WTC 92FL

To: Ms. Teresa Koebel, Manager, World Trade Project Management
From: C. John Lin, P.E.
Date: August 31, 1998
Subject: WTC - ALTERATION APPLICATION W-981121 - PANYNJ - 1 WTC, 92ND FLOOR - CORRIDOR AND LOBBY UPGRADE

THE PORT AUTHORITY OF NEW YORK AND NEW JERSEY
TENANT ALTERATION APPLICATION REVIEW REQUEST

E192C

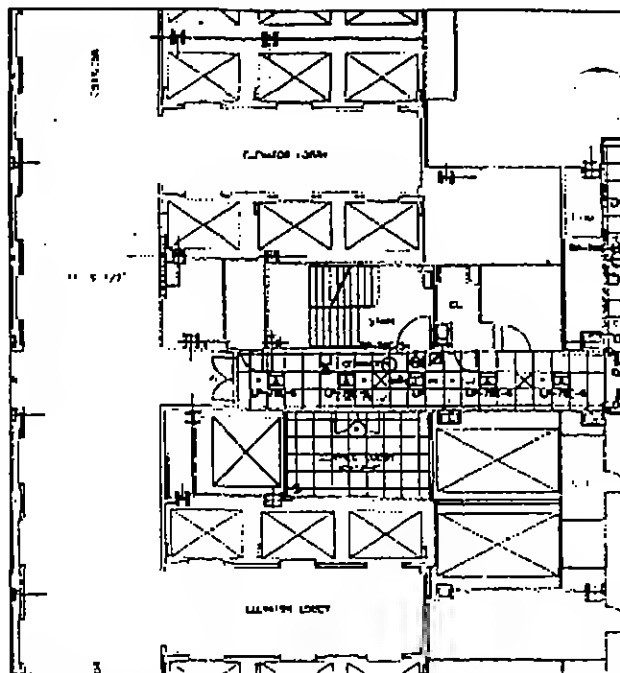
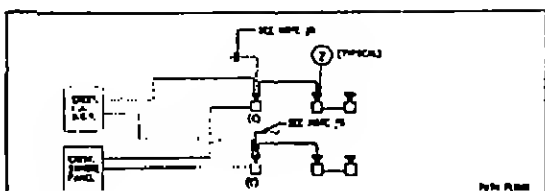
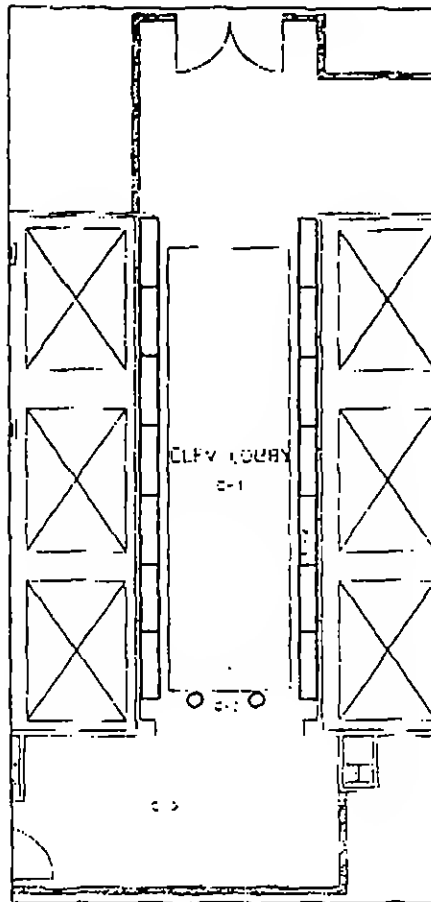
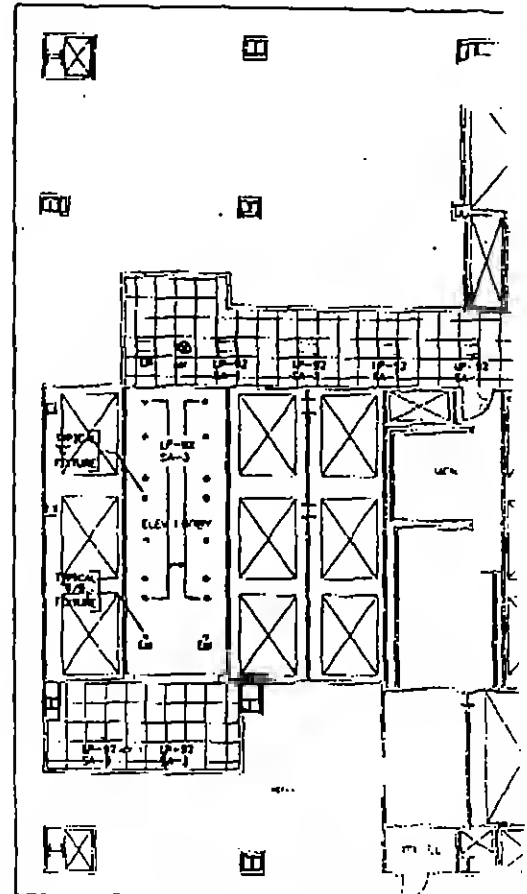
2. DRAWING E192C. The response to Comment 1 of the previous Rider is noted. Two (2) printouts of iso footcandle curves, Design File PA1 (EXHIBIT 1) and Design File PA2 (EXHIBIT 2) representing the Elevator Lobby and the Corridor, respectively, were submitted. Also submitted is a printout Design File PA2.des herein designated as EXHIBIT 3) showing levels of illumination along the Corridor during normal conditions
 - a) EXHIBIT 3 shows an average illumination of 12.9 fc and a minimum of 2.07 fc but EXHIBIT 1 and EXHIBIT 2 show that the levels of illumination drops to zero (no levels of illumination are shown) between the emergency fixtures.

Please clarify, and submit printout of levels of illumination similar to EXHIBIT 3, but under emergency condition with the average and minimum levels of illumination indicated.

- b) The levels of illumination submitted could not be verified since the following were not submitted, as requested in the previous Rider
 - i) Submit the photometric data for each type of emergency fixtures used, including a typical candlepower distribution curve for each. See Figure 10.3.
 - ii) Submit information and/or data used in calculating/verifying the levels of illumination

- c) On Drawing (E192C), show the specific type of fixtures to be used. The emergency fixtures are designated as B/B1 and A/A1. Please be specific.

Response to 2.a See enclosed calculations the footcandle levels do not drop to 0 they remain at 2.4 no additional curves indicate constant reading.

Response to 2.b See enclosed submissions of photometric data for each type of emergency fixture including typical candlepower, and distribution curve

Response to 2.c Drawing was corrected also enclosed is a catalogue cut of fixture intended to be used. Fixtures are designed for 120V on the lighting fixture list. Typical A-1 and B-1 fixtures are indicated on the plan. Emergency fixtures are indicated on the plan and the notes require all said fixtures to be wired for 120V. The A-1 and B-1 fixtures are those which are designated as Emergency fixtures.

Design File: PA1

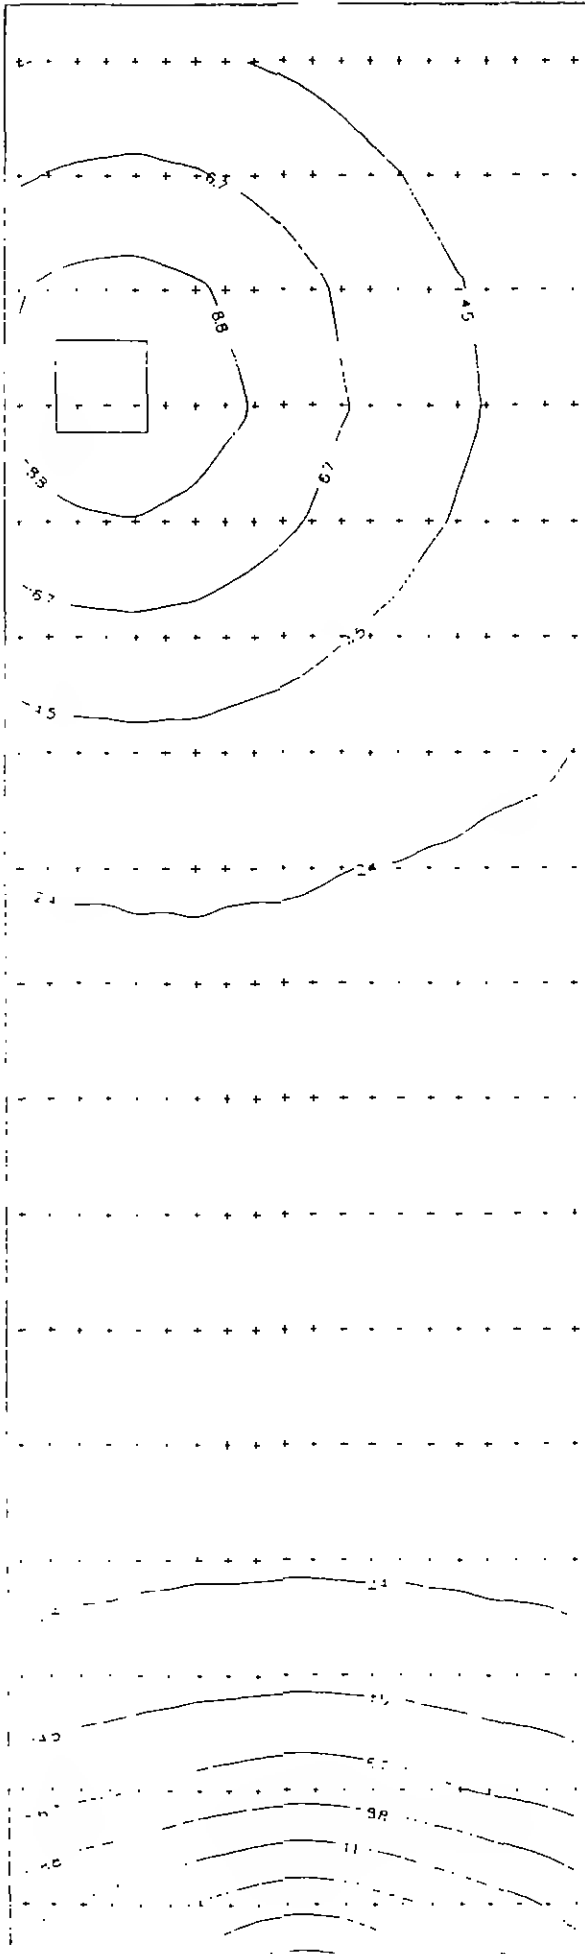
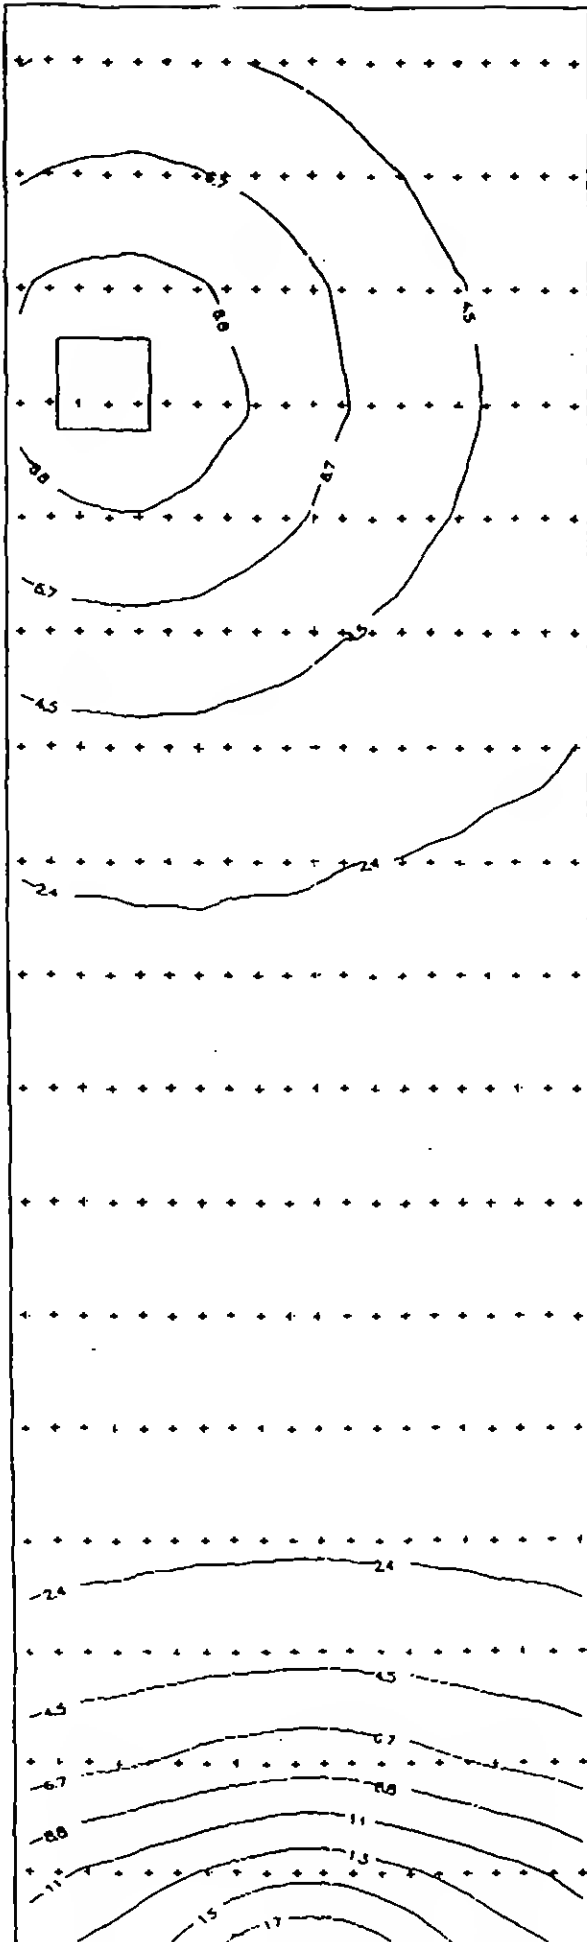
- a) EXHIBIT 3 shows an average illumination of 12.9 fc and a minimum of 2.07 fc but EXHIBIT 1 and EXHIBIT 2 show that the levels of illumination drops to zero (no levels of illumination are shown) between the emergency fixtures. Please clarify, and submit printout of levels of illumination similar to EXHIBIT 3, but under emergency condition with the average and minimum levels of illumination indicated.
